Comprehensive Development Plan Fitchburg Minerals Property

South of Lacy Road & East of Fitchrona Road
City of Fitchburg
Dane County, Wisconsin

RE:
Fitchburg Minerals
Comprehensive Development Plan
Response to Evaluation Comments

PLANNING STAFF REVIEW #1 DATED 04/05/21

**CONCEPTUAL SITE, UTILITY
AND PHASING PLAN**

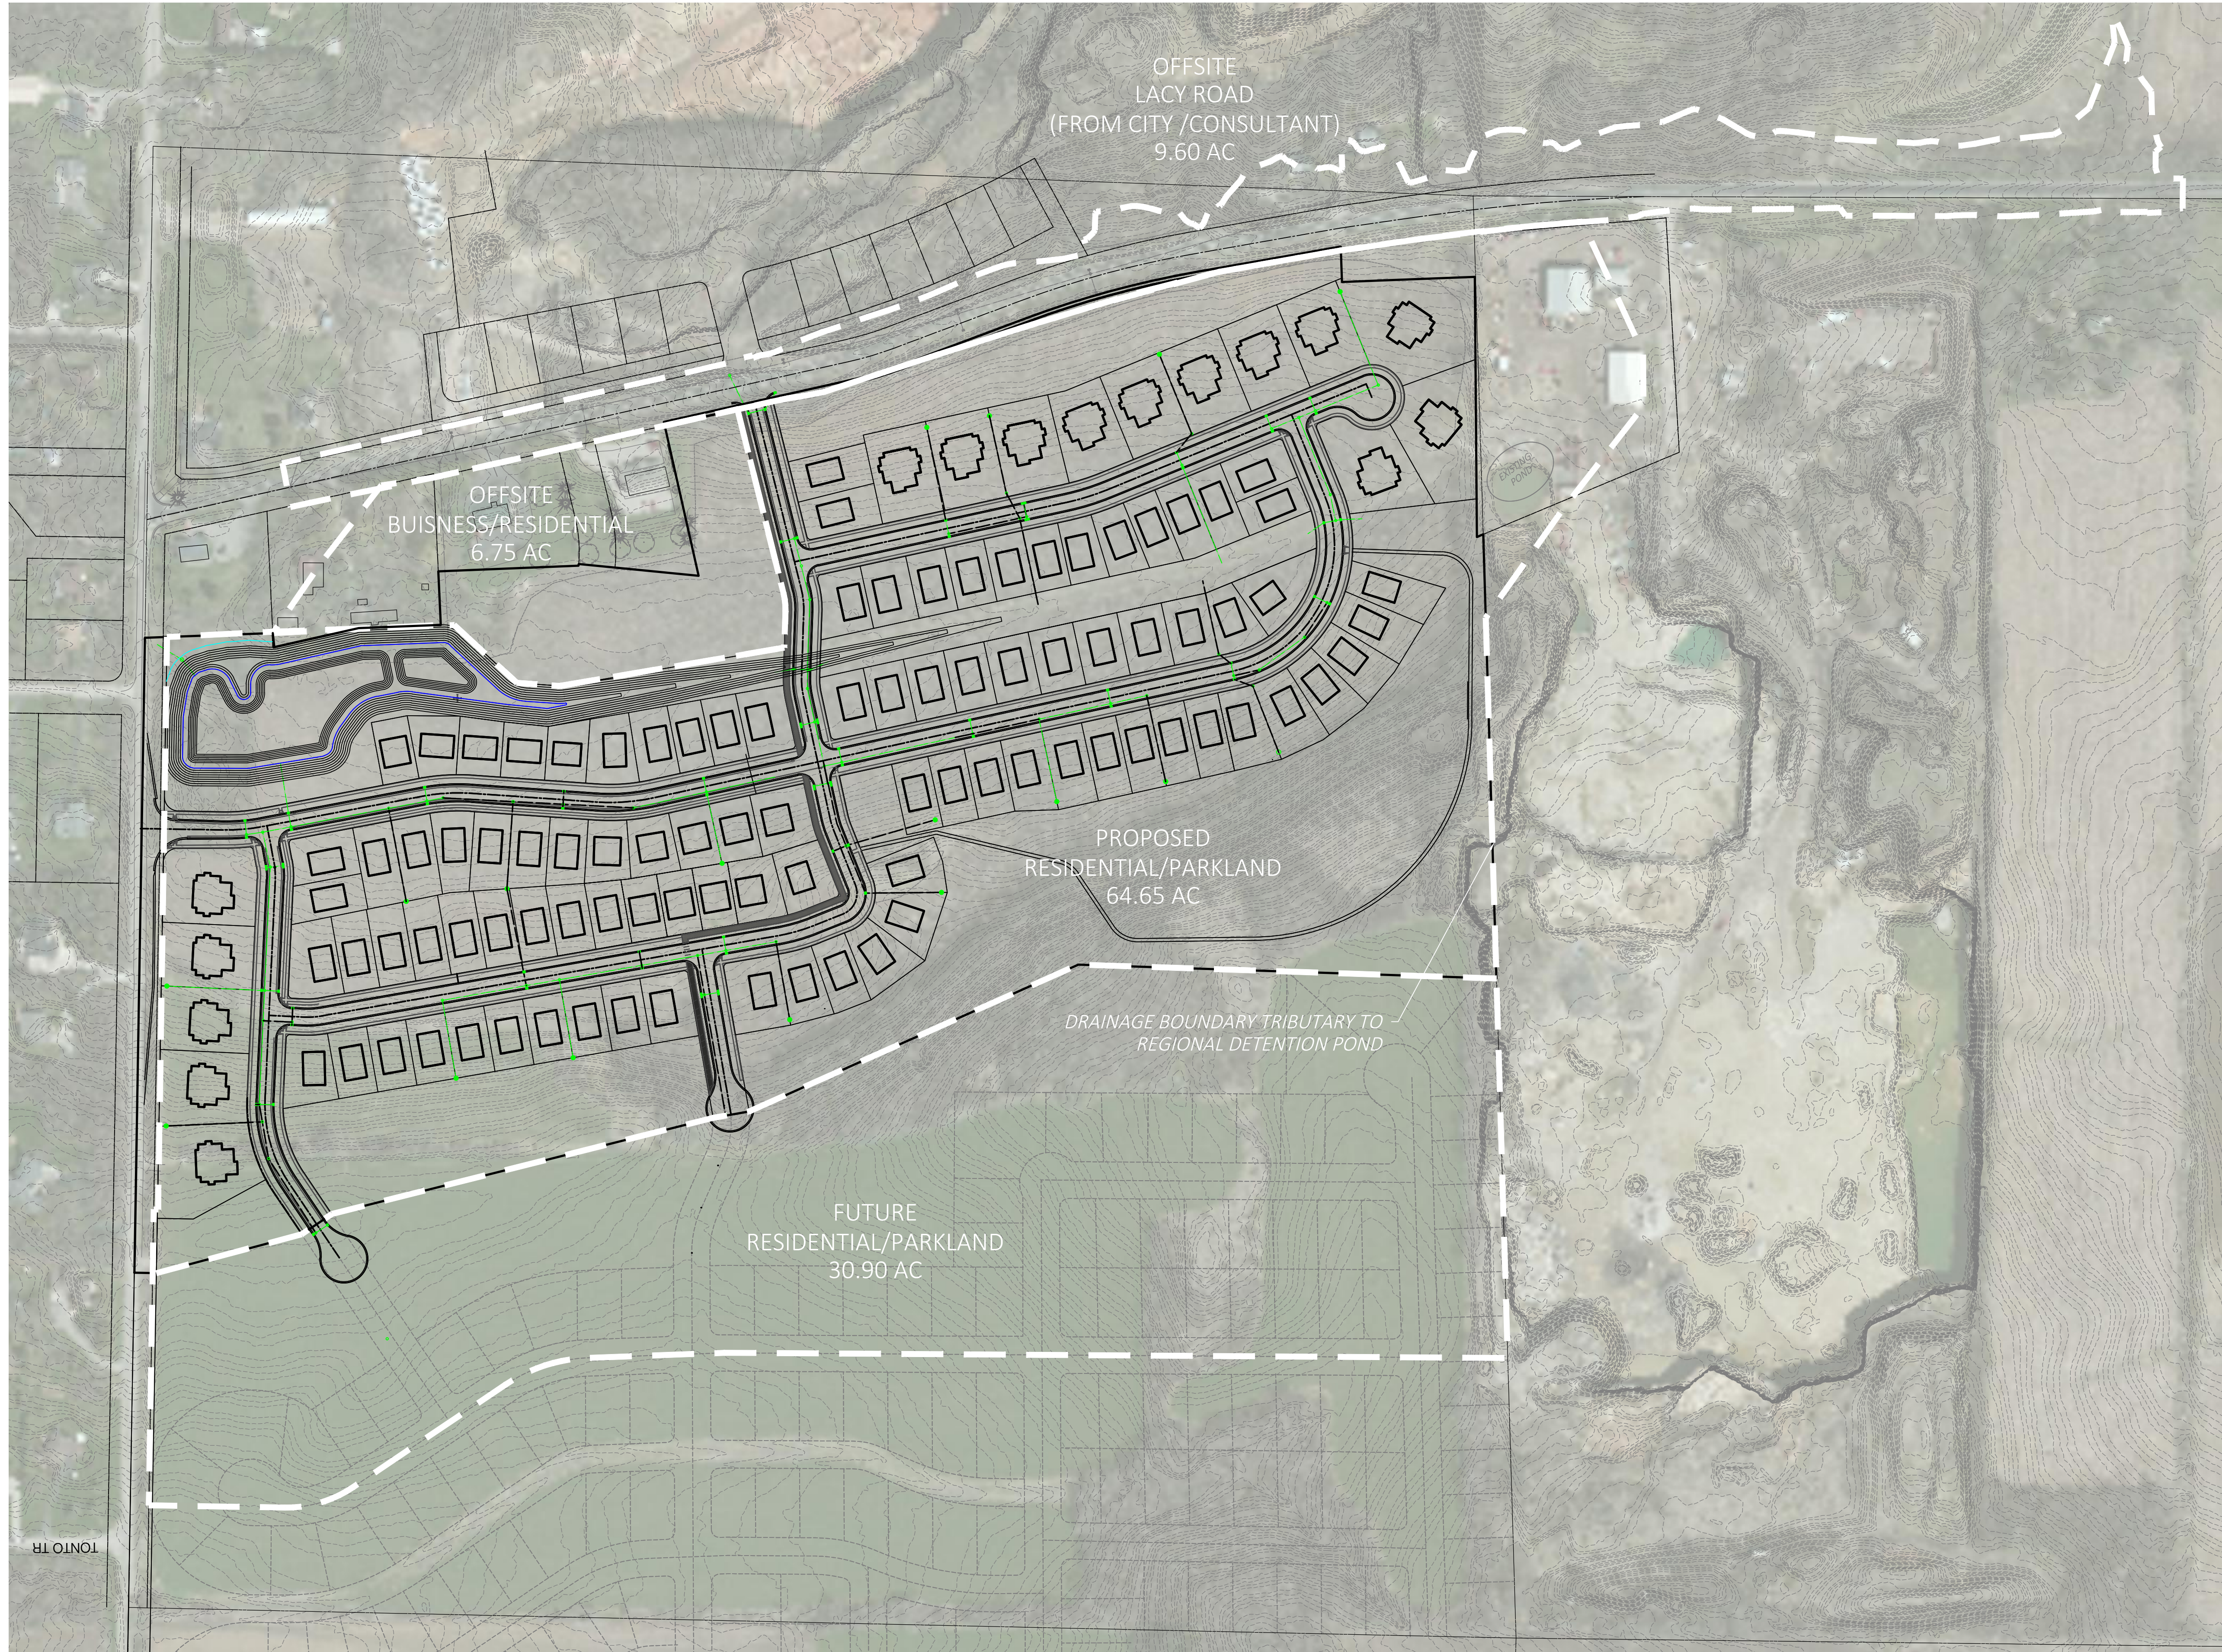
- The streets labels are inconsistent between Exhibit 3 and the Plan & Profile documents.
 - Street labels have been coordinated on all exhibits.

3. Please indicate/correct the following in Section 3.4 and Exhibit 3:
 - The water main on Roads C and D shall be loop through the future outlot for future development (lot size listed as 130,287 SF) and ultimately connect to the water main on Lacy Road.

- 8-inch minimum sized water mains shall be installed and looped within the plat as directed by the City. Final sizes to be determined by the City during the planning process.

- Provide proposed water and sanitary usages for this development.
 - a. As the design and entitlement approvals proceed, the details of these comments will be reviewed and resolved with public works.

SHEET TITLE
STORM WATER SYSTEM
SCHEMATIC LAYOUT

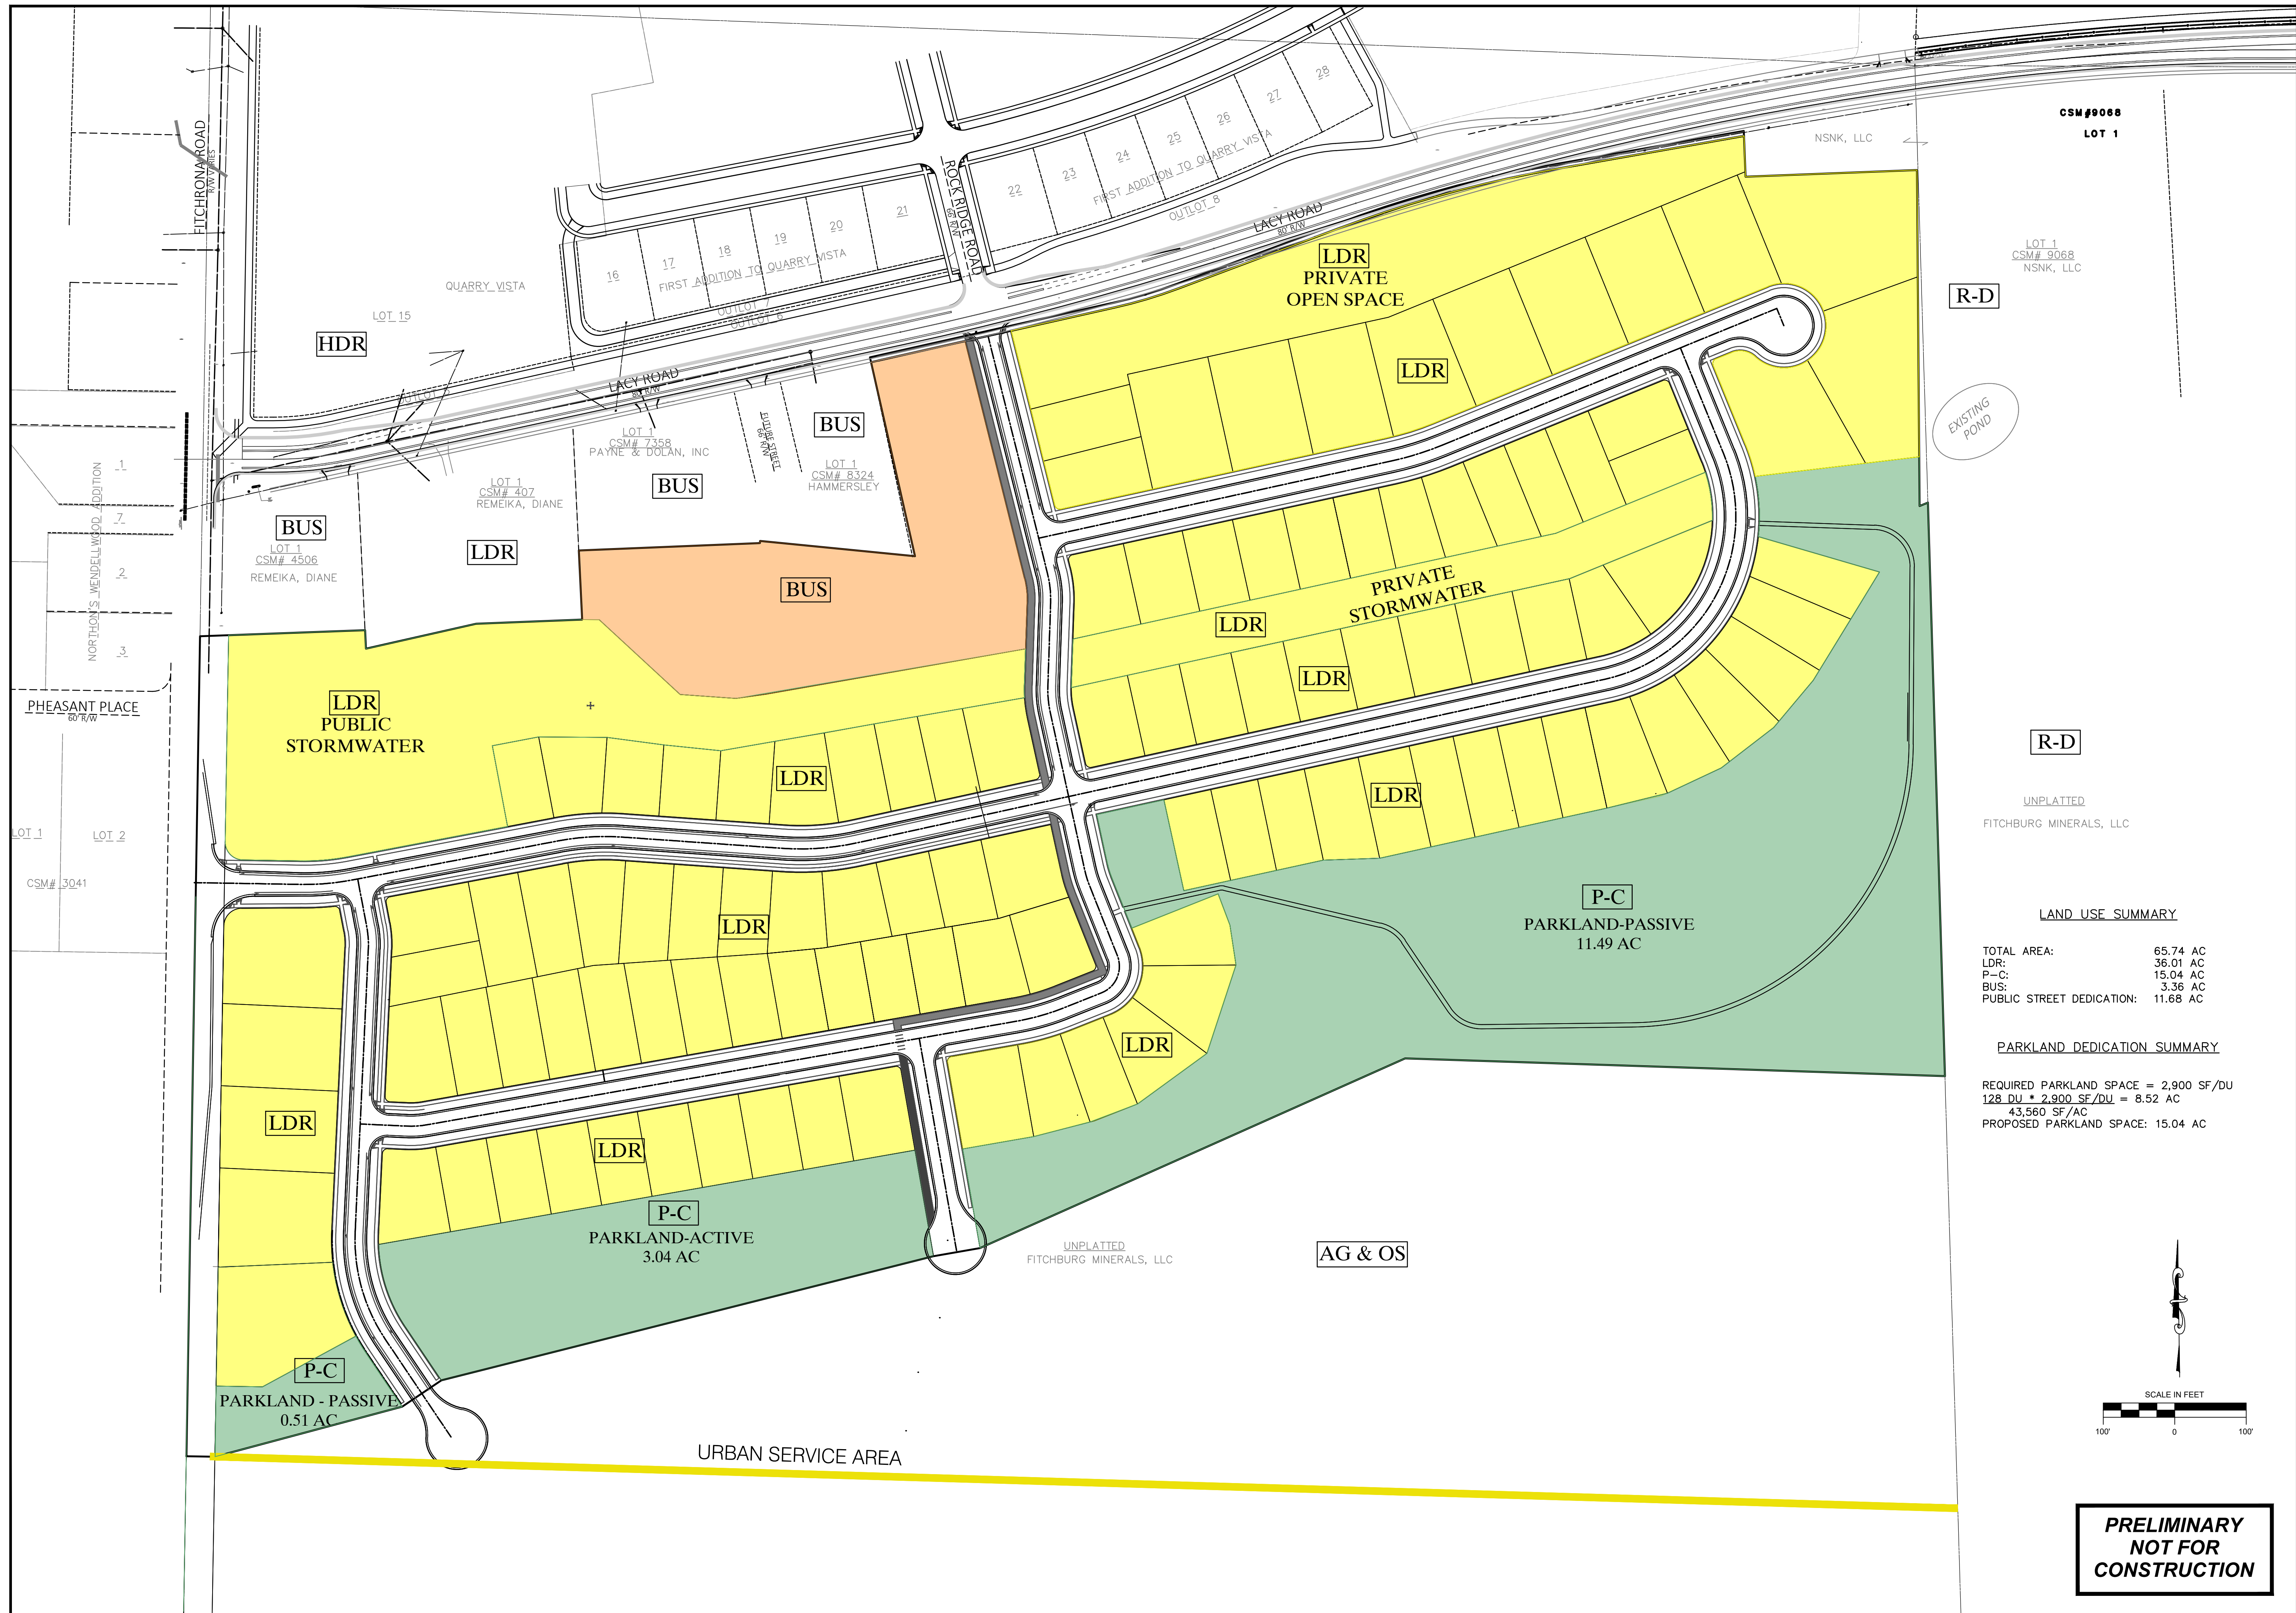
6. Stormwater facilities should be designed using DNR's post-construction technical standards, available at: https://dnr.wi.gov/topic/stormwater/standards/postconst_standards.html. The report did not use the correct values for the design storms.
